# Addendum No. 1

Contract No.: DA00263

Landscaping, Sodding, Grading, Sidewalk And Patio Construction At The Camden County

Rest Area, Located In Camden County

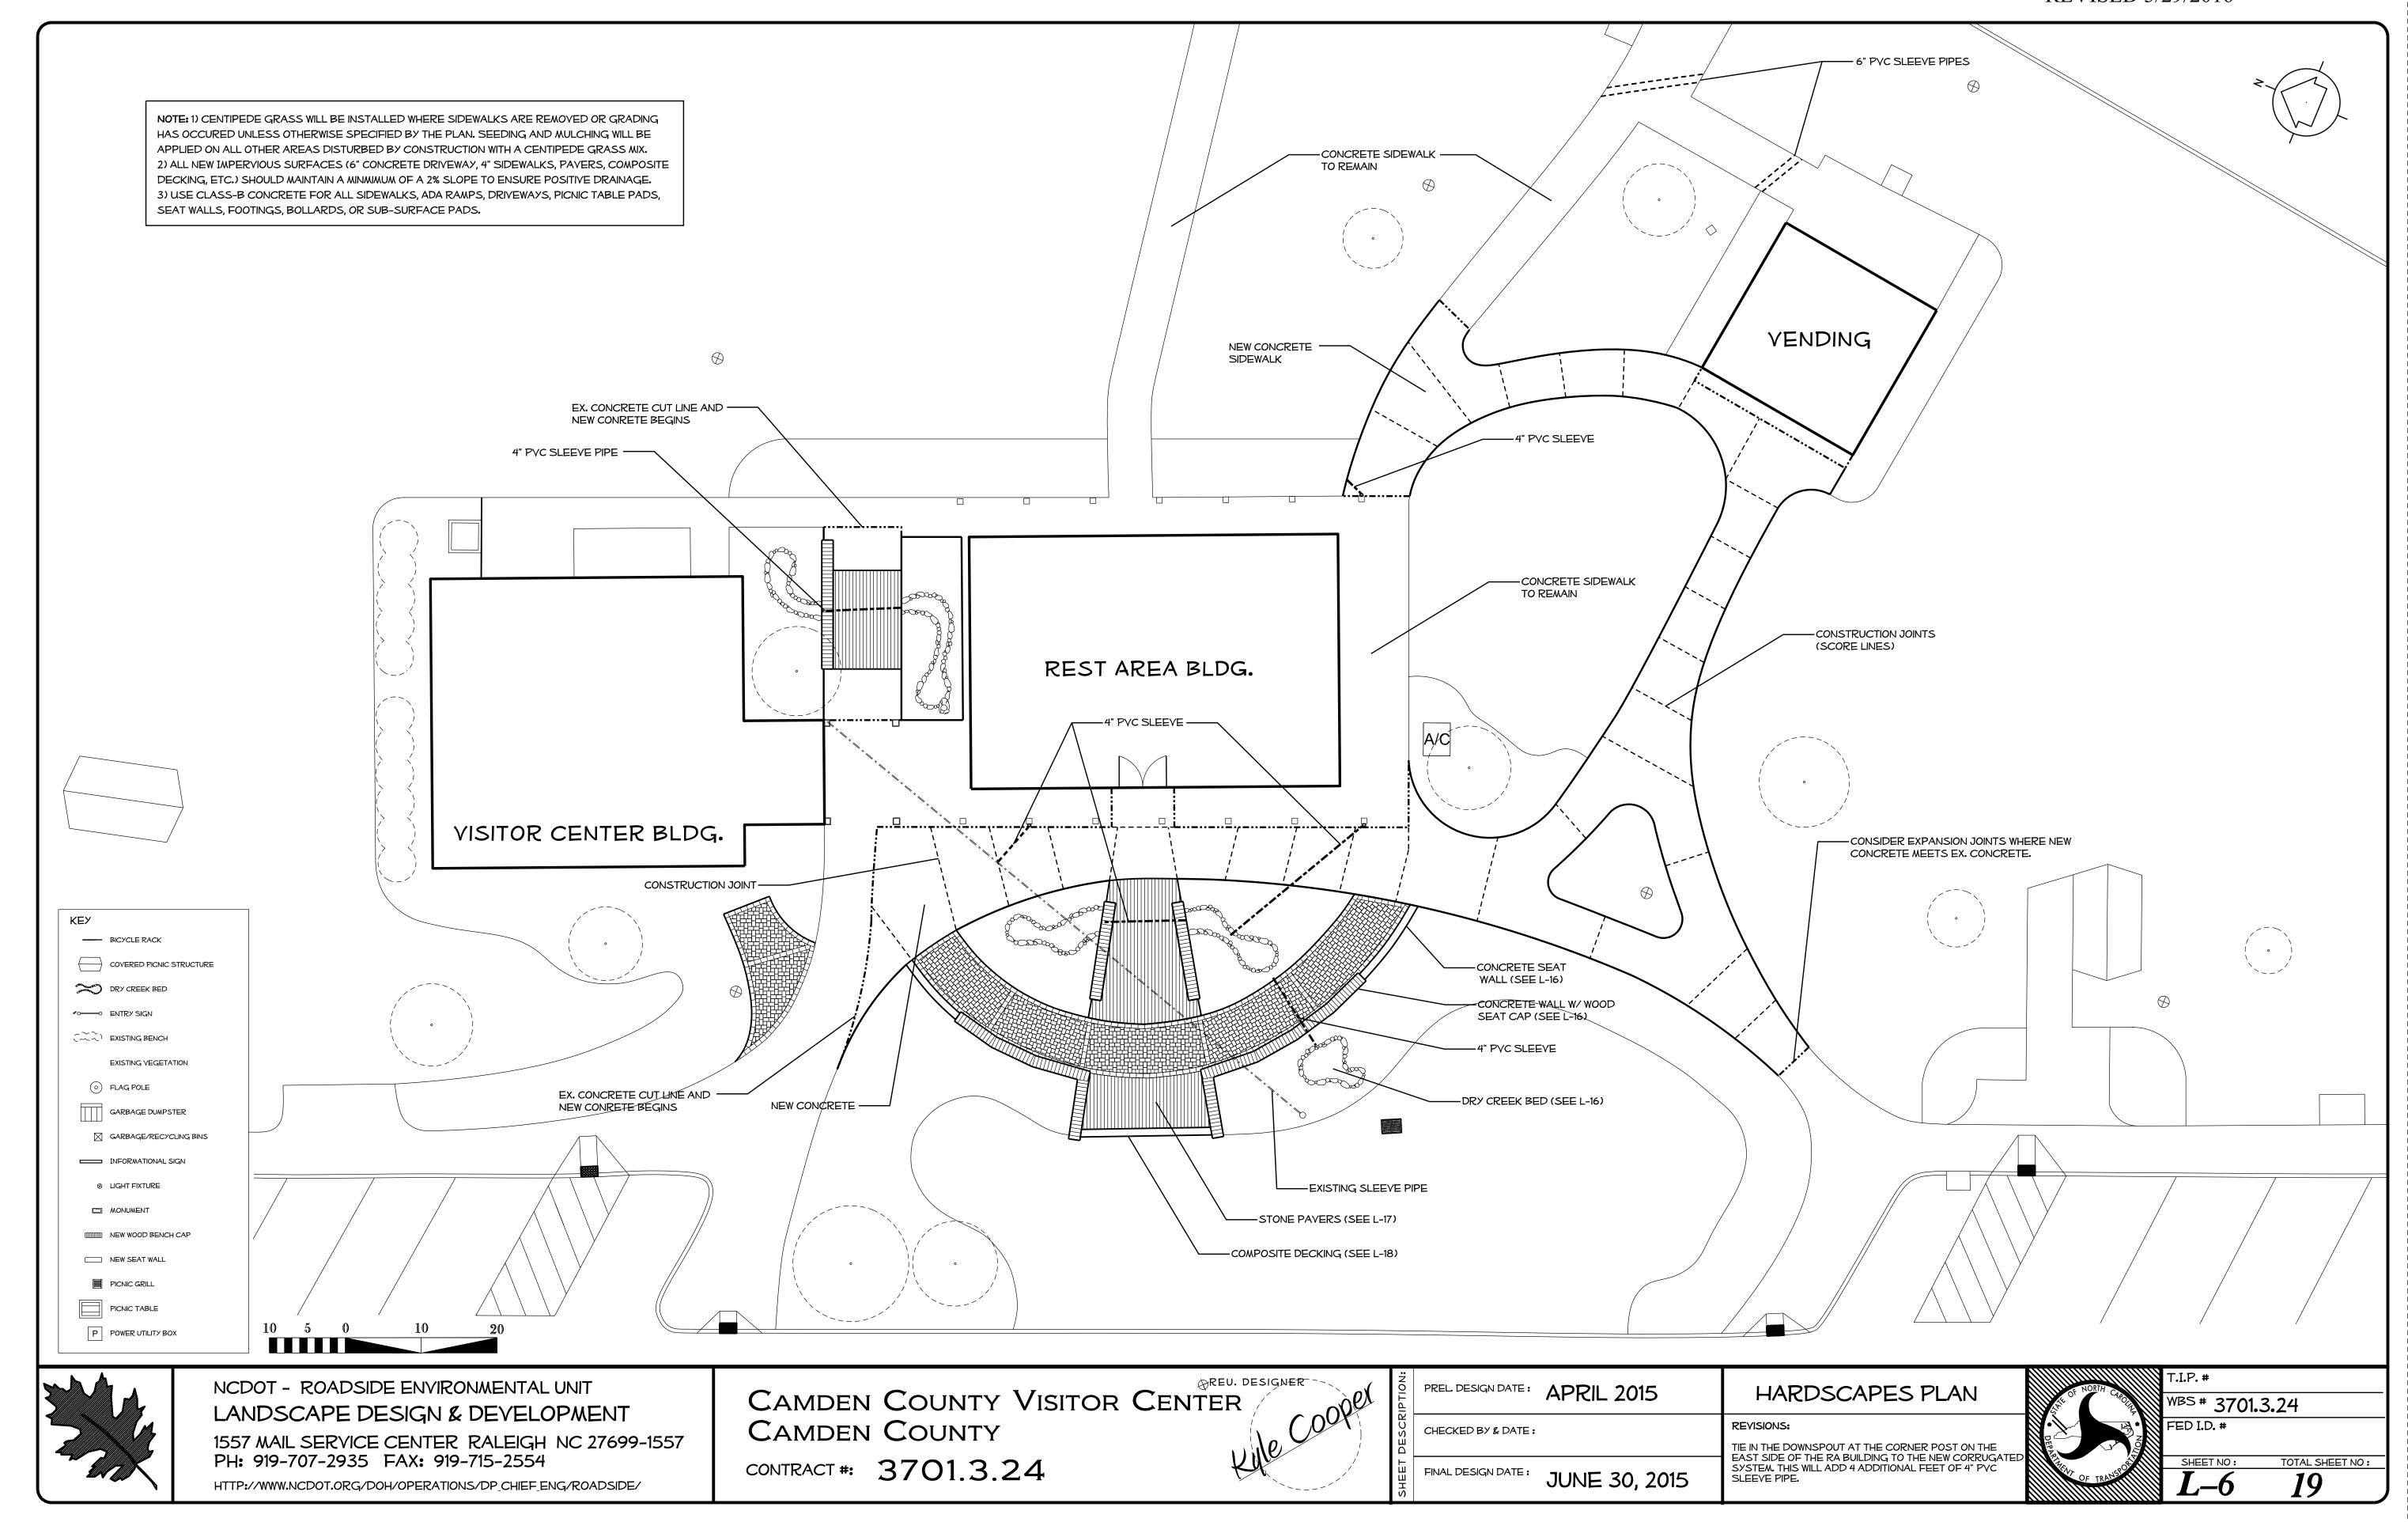
Plan Sheet No.L6 "Hardscapes Plan" has been revised to illustrate a section of 4" PVC Sleeve Pipe and fittings to attach the drainage pipe connecting the gutter downspout (Southeastern Corner of the Rest Area Building), under the proposed sidewalk, to the existing drainage system. Please void existing Plan Sheet No. L6 and staple revised Plan Sheet No.L6 thereto.

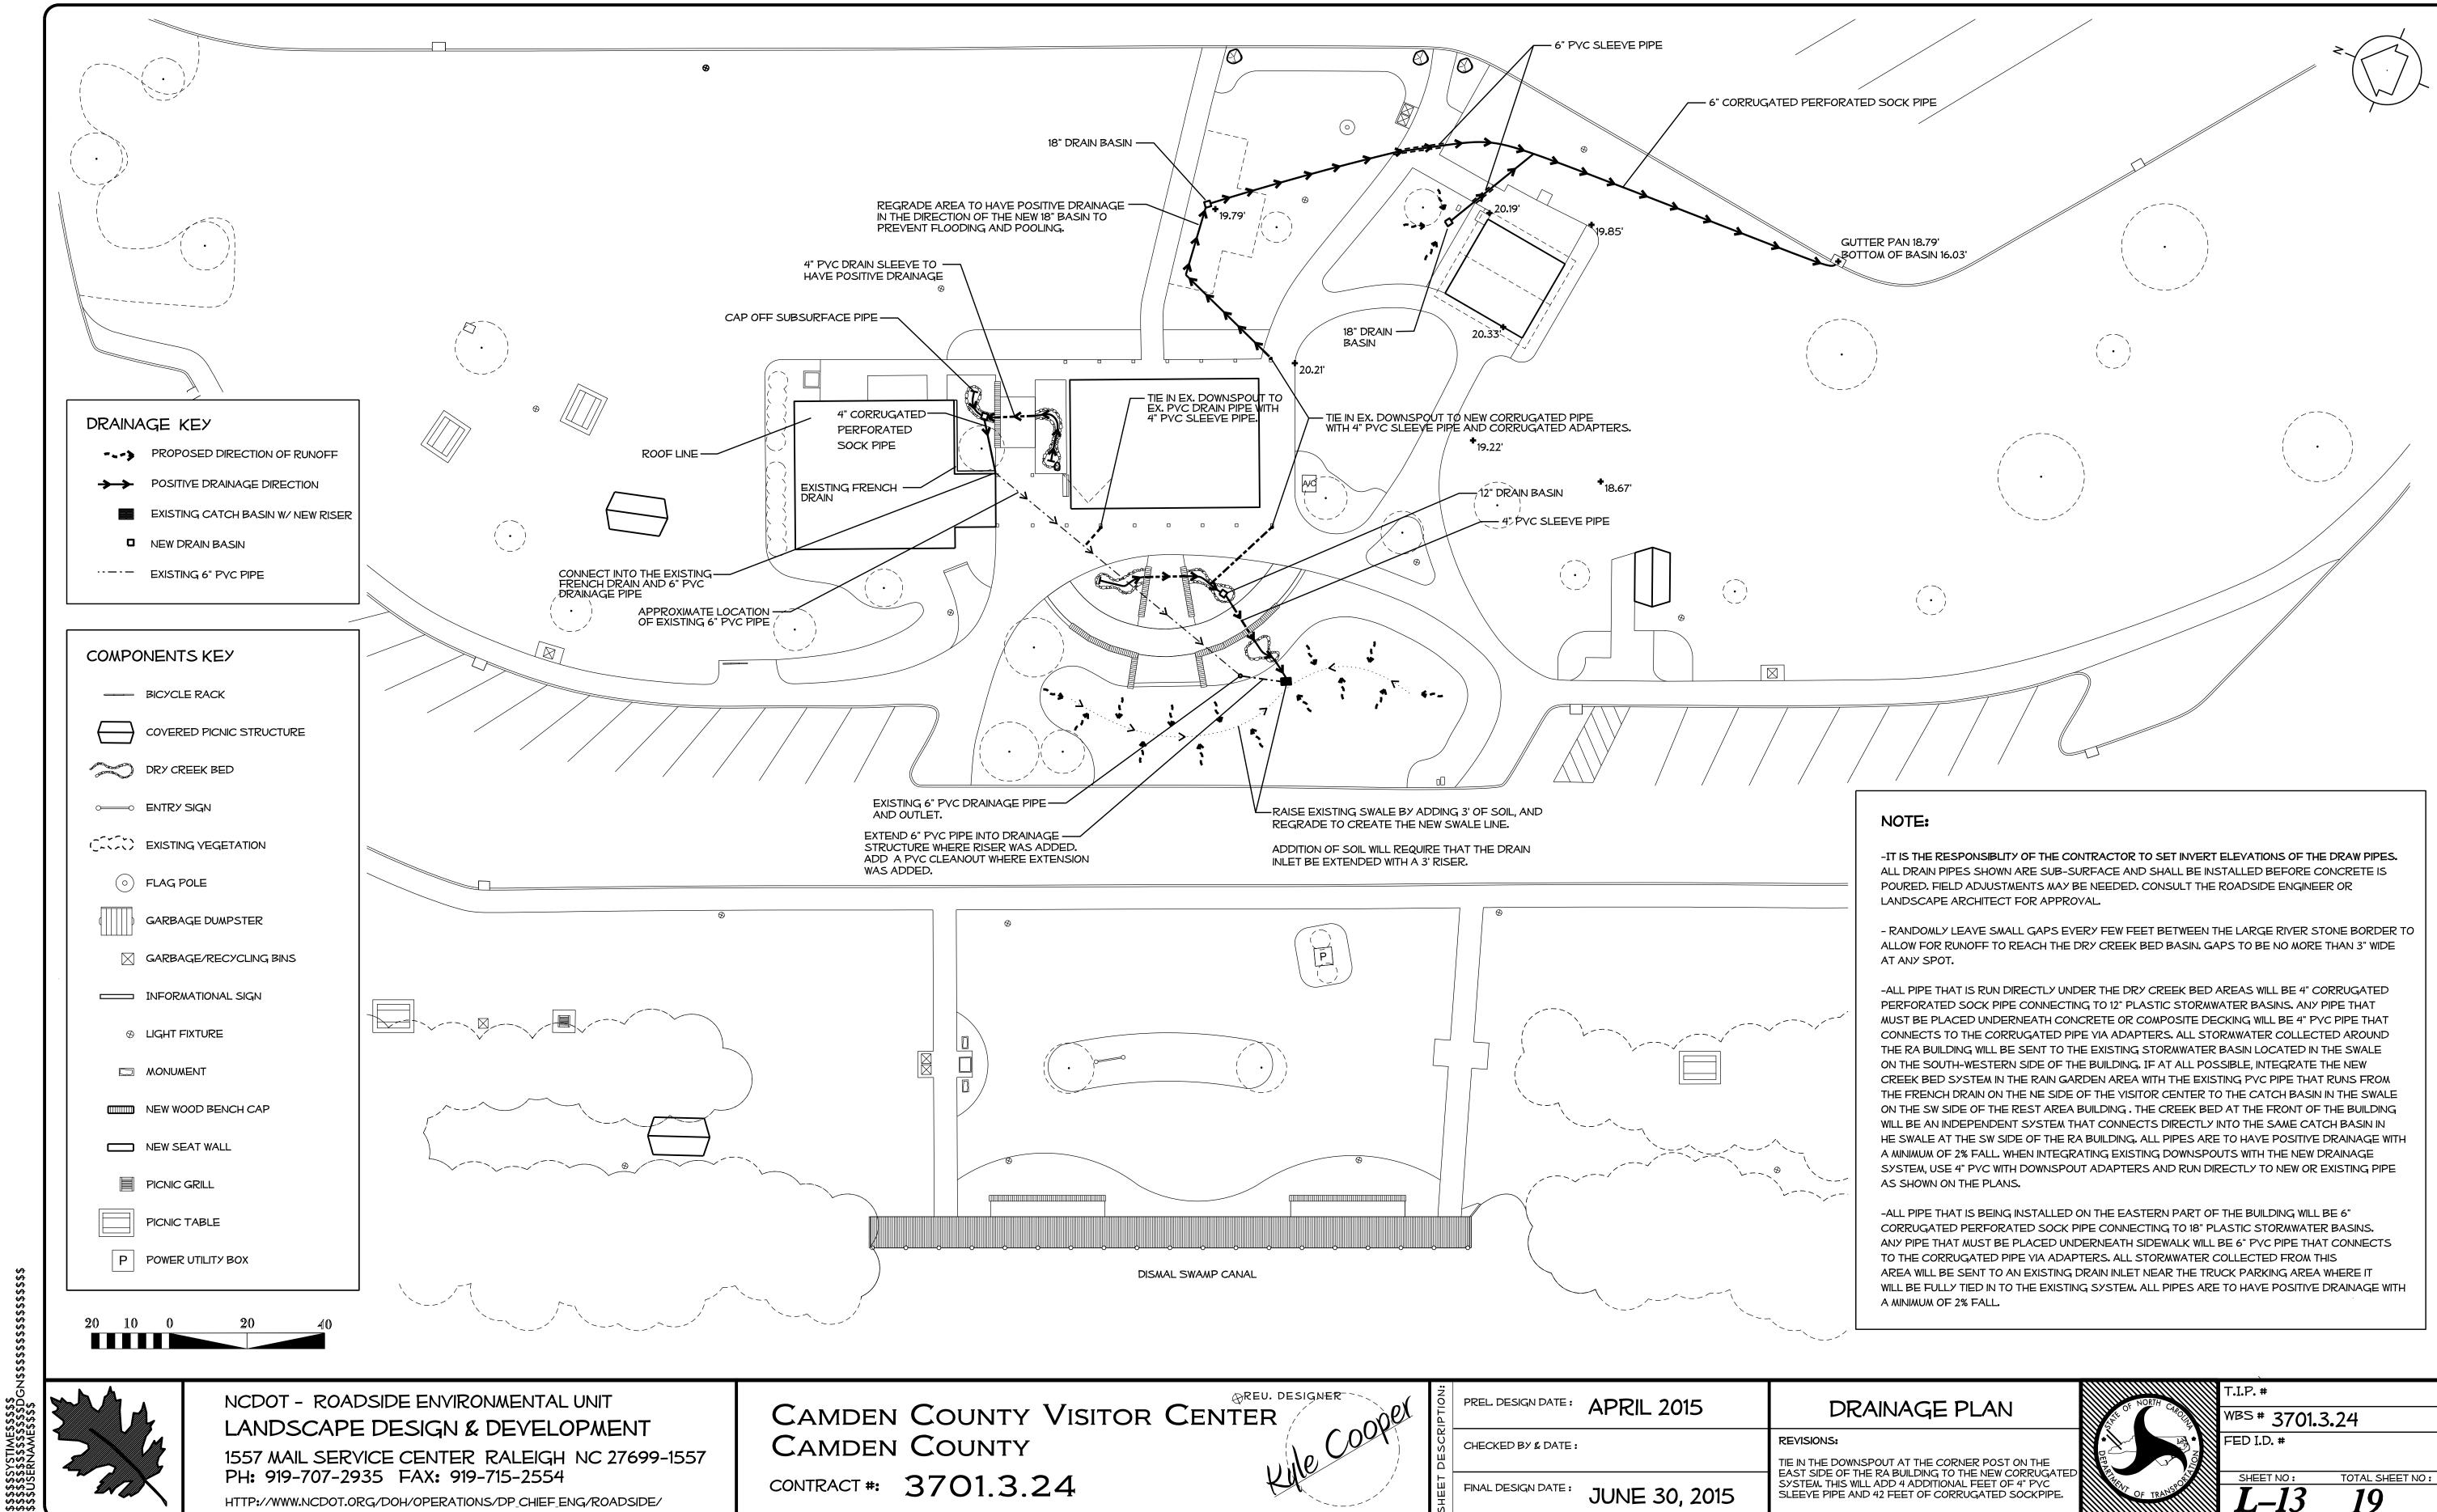
Plan Sheet No.L13 "Drainage Plan" has been revised to illustrate the drainage pipe connecting the gutter downspout (Southeastern Corner of the Rest Area Building) to the existing drainage system. Please void existing Plan Sheet No.L13 and staple revised Plan Sheet No.L13 thereto.

BOULDER PLACEMENT DETAIL **TYPICAL**

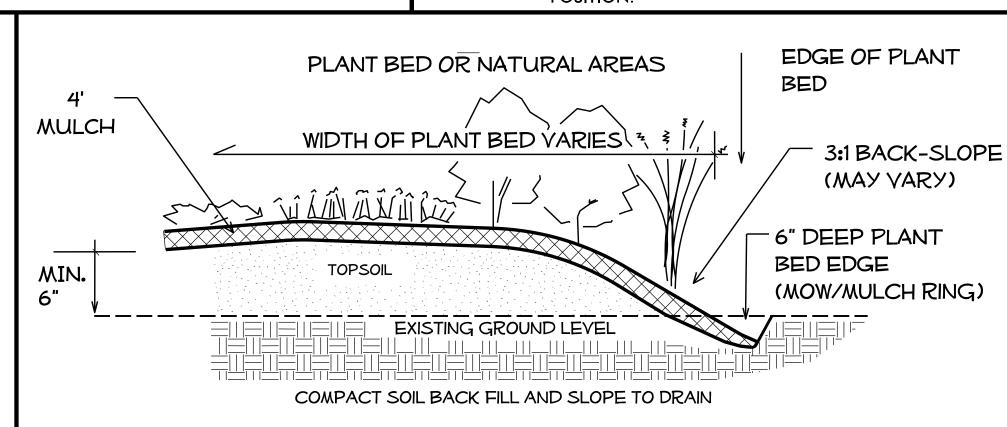
Plan Sheet No. 15 "Planting Details – Boulder Placement Detail Typical" has been revised to clarify that the Contractor shall be responsible for providing the stones. Please void existing Page No. 15 and staple revised Page No. 15 thereto.

LANDSCAPE BOULDERS ARE TO BE PROVIDED BY THE CONTRACTOR, NOT NCDOT.
